SUBJECT: Grand Gulf Nuclear Station
 Units 1 and 2
 Docket Nos. 50-416/417
 File 0272/L-952/11000
 Advance Information Combustible
 Gas Control & By-Pass Leakage
 (MAEC-62)
 AECM-63

Enclosed are five (5) copies of information requested by your July 19, 1973, letter concerning the combustible gas control system and bypass leakage.

This is advance information and will be identical in content to information filed later this month as part of Amendment 11 to the Grand Gulf Preliminary Safety Analysis Report.

FIGURE R6.2.39-1

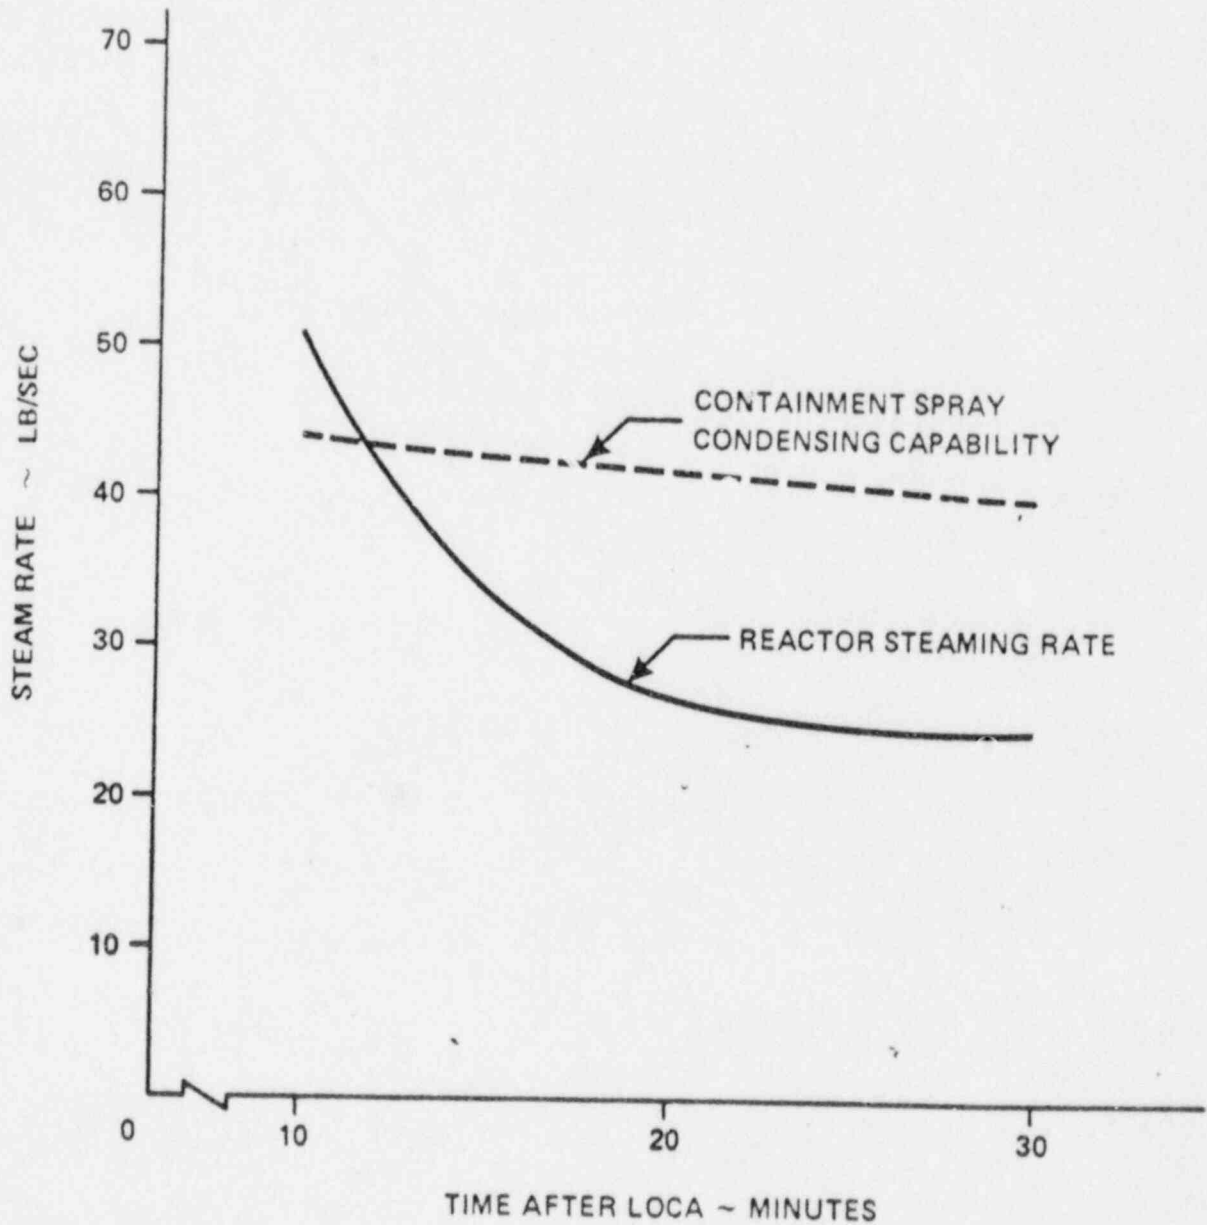
- Item 6.2.39 Provide the results of an analysis of the plant's capability to allow initiation of the hydrogen recirculation system at 10 minutes following a loss-of-coolant accident. Define the spectrum of primary system break sizes for which this capability may exist and discuss the specific limitations which determine the unacceptable break ranges. As a minimum, the following possible limitations should be addressed:
- a. containment spray heat capacity;
 - b. RHR system interlocks;
 - c. capability of the recirculation system to effectively mix the drywell and containment atmospheres considering the evolution rate of hydrogen due to metal-water reaction;
 - d. interlocks on the recirculation system valves; and
 - e. requirements for operator action.

- a. As discussed in the response to question 6.2.41, the containment spray system is capable of maintaining containment pressures and temperatures within their design limits, assuming that the hydrogen recirculation system is initiated at 10 minutes or later after a LOCA. A very conservative end point calculation, assuming that the containment is at peak design conditions, indicates that the containment spray system is capable of condensing all the steam being produced in the reactor vessel at approximately 11.7 minutes after the LOCA. The results of this analysis are shown in Figure R6.2.39-1.

The analysis did not assume transient effects which would allow the containment pressure to fluctuate between initial conditions at 10 minutes (5 psig) and design conditions (15 psig). The analysis assumed the pressure remained constant and calculated the time at which the system may be started without increasing the temperature of the containment. The initial containment conditions are such that approximately 20,000 lb of additional steam can be absorbed by the containment atmosphere prior to exceeding the design pressure. If the hydrogen mixing system is postulated to start at 10 minutes, it has been determined that less than 6,000 lb of additional steam is produced prior to the containment spray having the capability to condense all the steam produced. Therefore, adequate margin exists to enable a start time of 10 minutes.

FIGURE R6.2.42-1

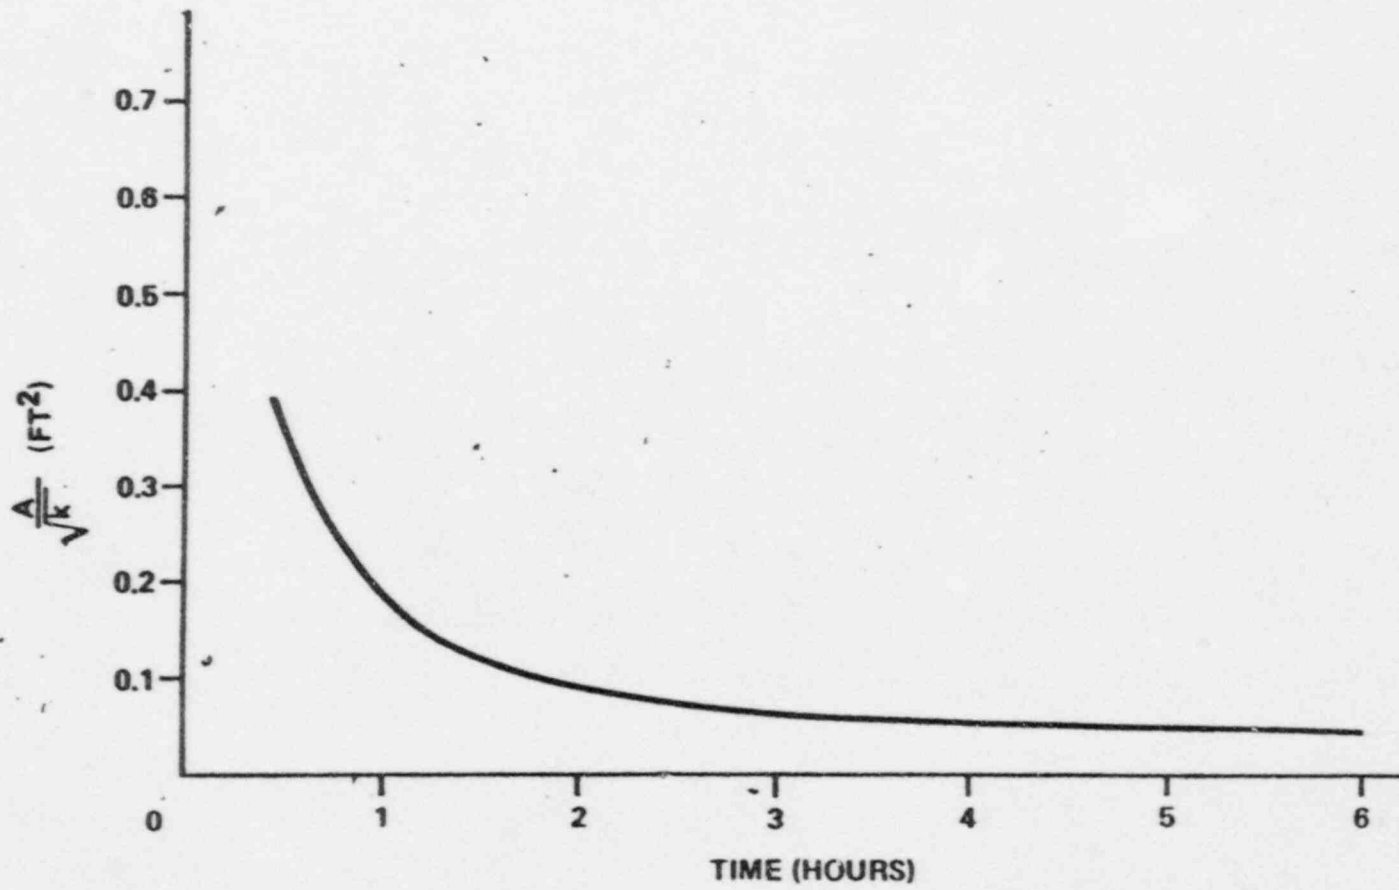
Item 6.2.42 Provide sensitivity analyses which relate the allowable bypass capacity (Figure 6.2-26), for small primary system breaks, to the following means of mitigating or terminating bypass leakage:

The maximum allowable bypass capacity ($A/\sqrt{k} = .043 \text{ ft}^2$) is based on a normal reactor shutdown (depressurization and cooldown) over a six-hour period. If this time is decreased, the allowable bypass capacity will increase accordingly. The maximum time at which the reactor could be depressurized without exceeding a vessel cooldown rate of 100 F/hr is approximately three hours. This would result in an approximate doubling of the maximum allowable bypass capacity. Bypass capacity vs. time is shown in Figure R6.2.42-1.

The maximum bypass capacity is inversely proportional to the shutdown time; the shorter the shutdown time the larger the allowable leakage capacity. Maximum shutdown rate could approximately double the allowable leakage capacity.
